**ASHLAND PLANNING COMMISSION
REGULAR MEETING
October 10, 2017
AGENDA**

PLANNING ACTION: 2017-00406

**ASHLAND PLANNING DEPARTMENT
STAFF REPORT ADDENDUM**

SISKIYOU BELLVIEW PHASE II
Project: A New Medium Density Residential Development
Owner: Raven Woodworks
2300 Siskiyou Boulevard
ASHLAND, OREGON 97520
MAP: 39 1E 14CA TAX LOT: 7800

A0.01
SITE PLAN

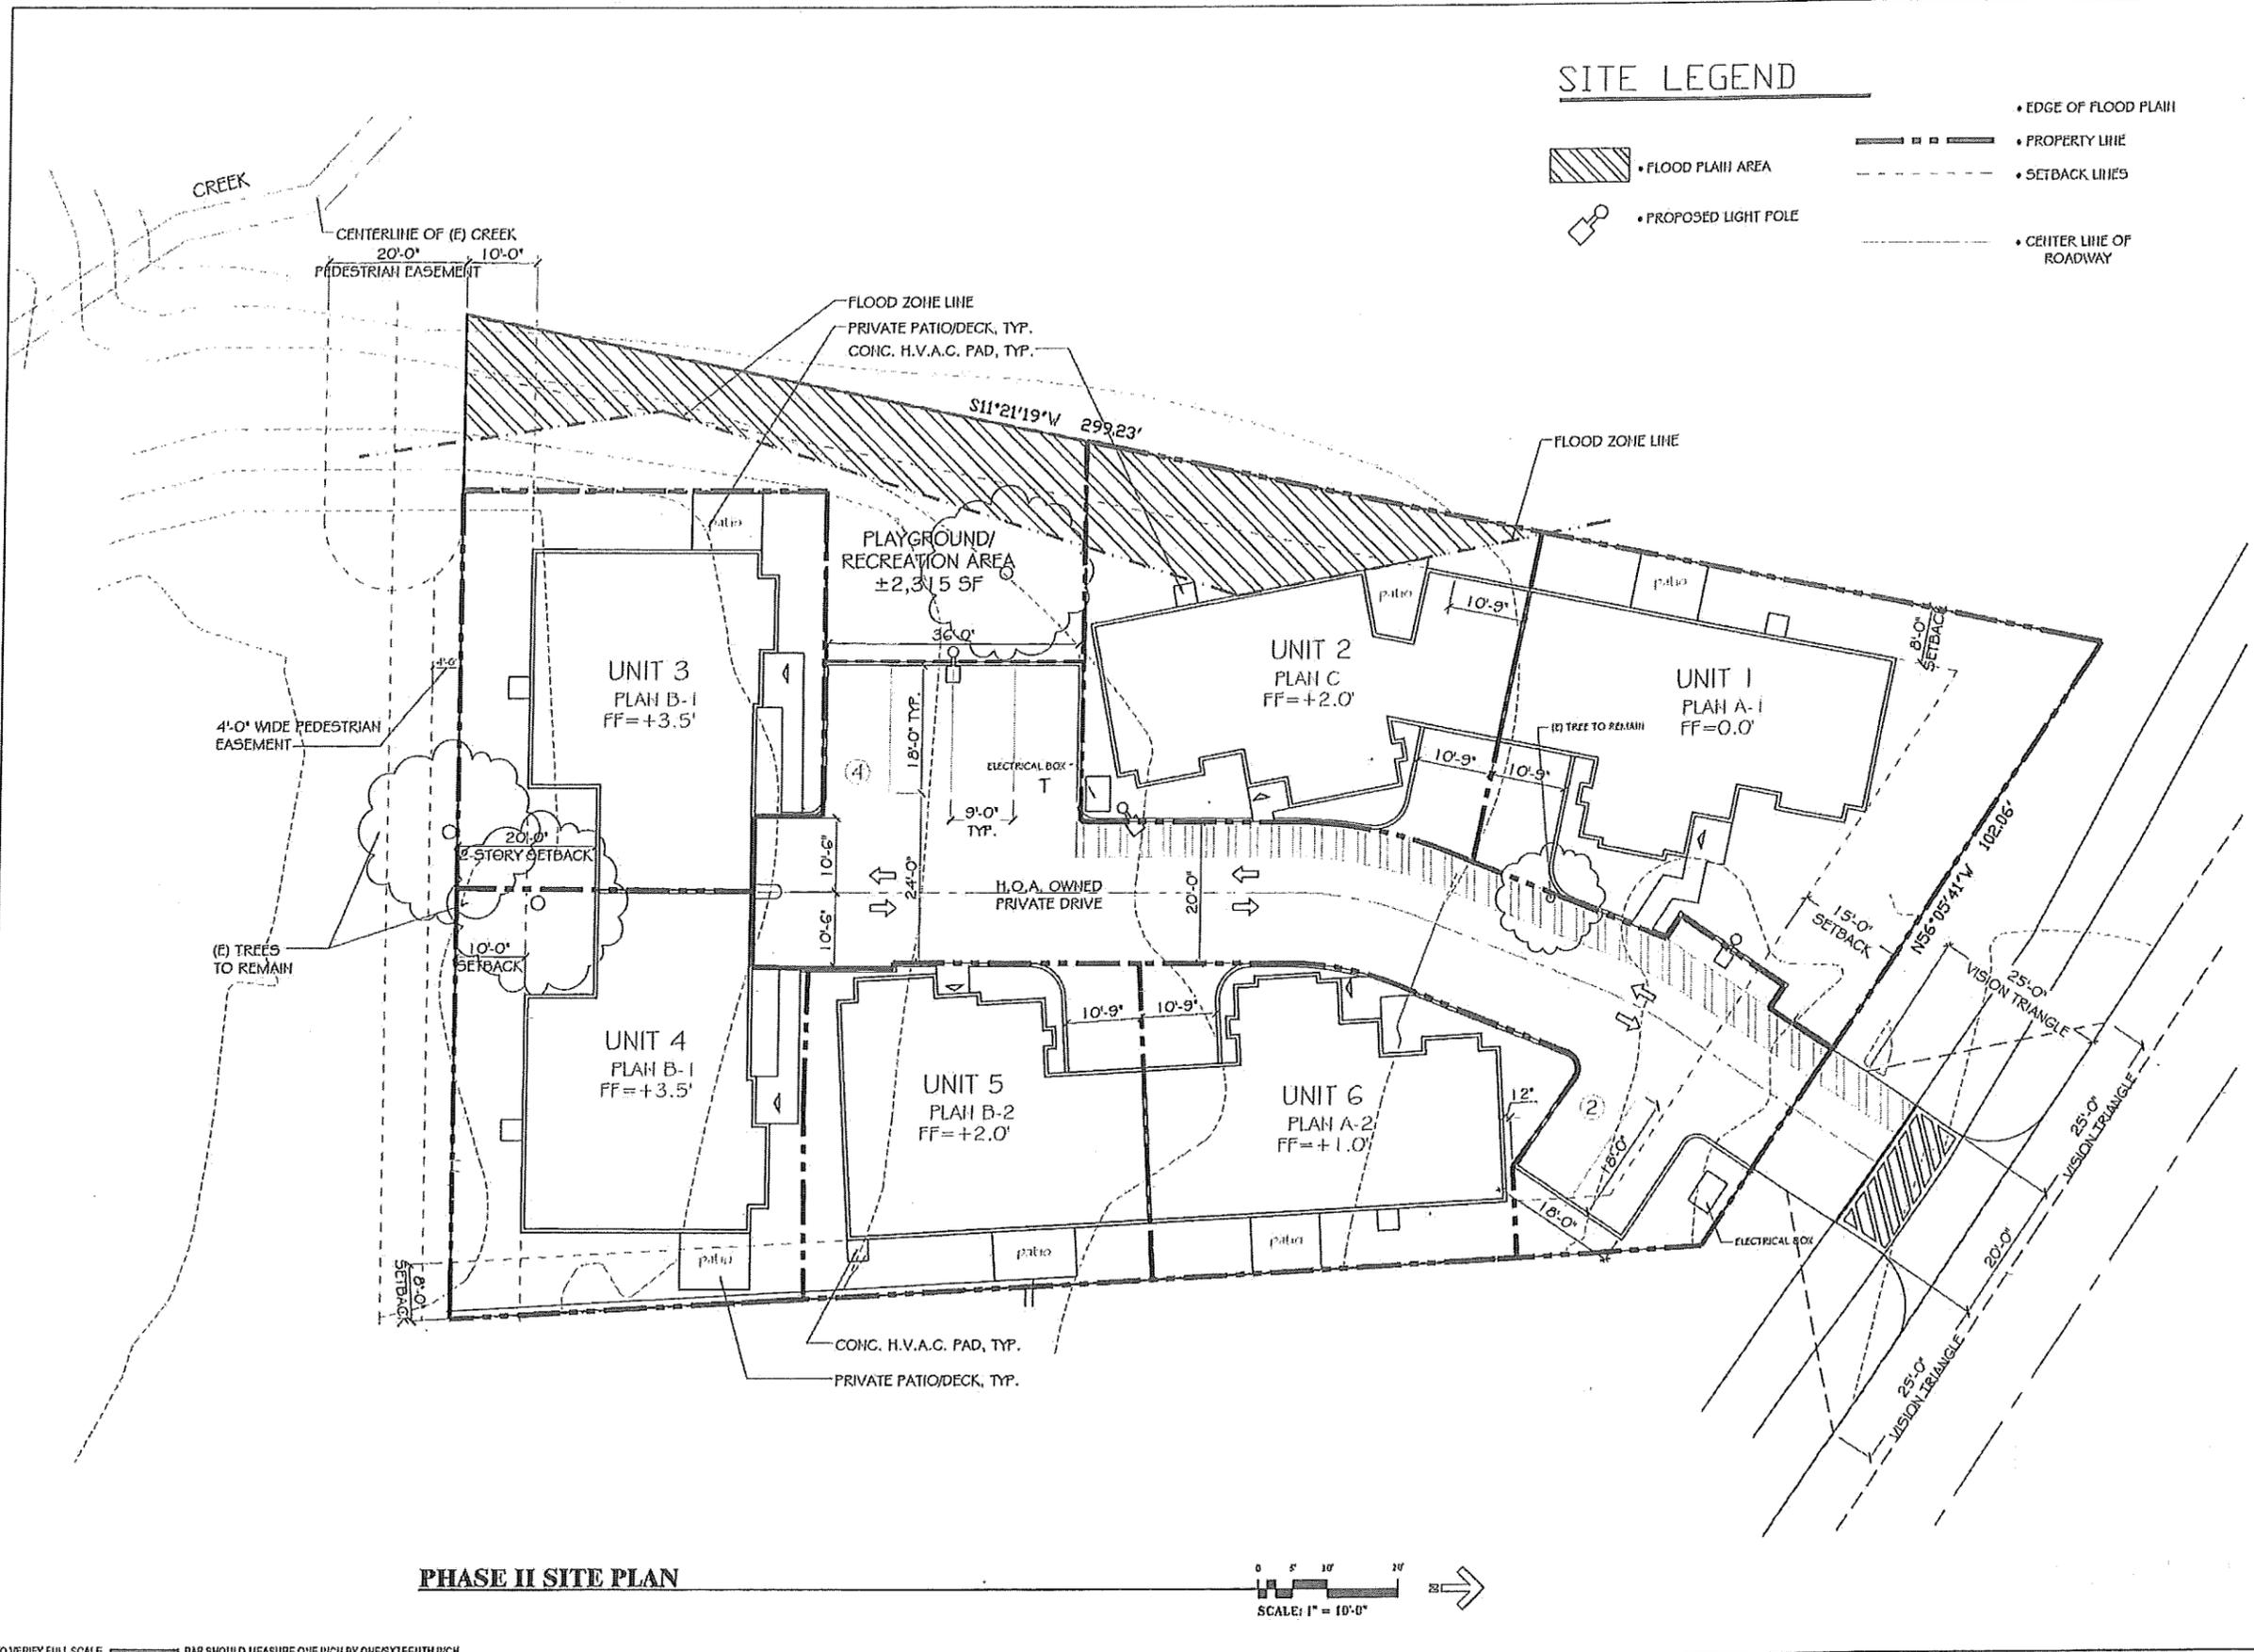
On site plans A0.01, A0.02, A0.03 and A0.04 from the application packet, the building set-back for the one-story portion of unit 3 and unit 4 is marked as ten feet (20 feet for the 2-story portion). If the true property lines for 911 and 913 Bellview are determined to be closer to Siskiyou Blvd (North), as supported by the attached survey, the application, should be denied on the basis of failure to provide the required set-back (10 feet per one story - 20 feet for two story portion) for units 3 and 4.

SHEET 2 OF 2

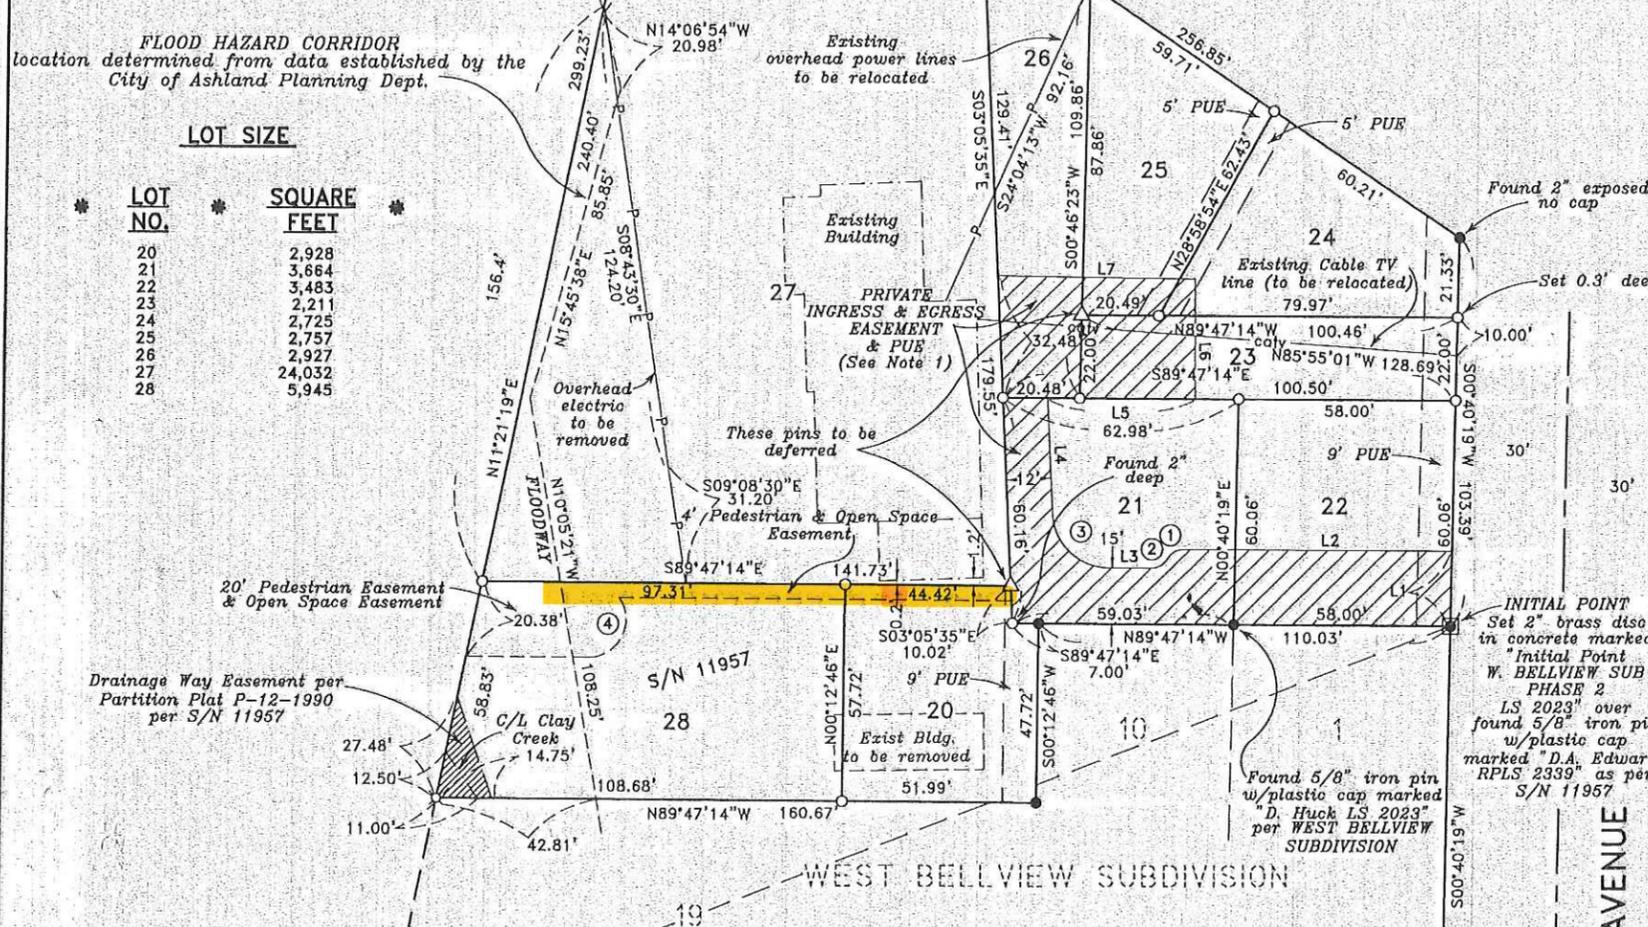
I have attached Survey #15836 done by Hoffbuhr and Associates (Medford) in 1997 (the year the subdivision was created). The survey shows the placement of a four foot pedestrian easement on lot 28 (911 Bellview Ave) and 20 (913 Bellview Ave) and shows the property boundary for 2300 Siskiyou Blvd. on the northern edge (toward Siskiyou Blvd.) of that easement. The survey further shows that the rear property boundaries for lots 28 and 20 are more northerly than the boundaries of lots 10 and 1 (915 Bellview Ave #1 & #2). On site plan A0.01 from the Zoning Permit application, the rear property boundaries for lots 28 & 20 are shown to be in a straight line with the those of lots 10 & 1 and shows the easement placement on the 2300 Siskiyou Blvd. side of the property line. At my request, Darrell Huck, Survey Manager for Hoffbuhr and Associates, compared the site plans in the application to the survey and concluded there are inconsistencies between what is documented in the survey and what is shown in the site plan drawings.
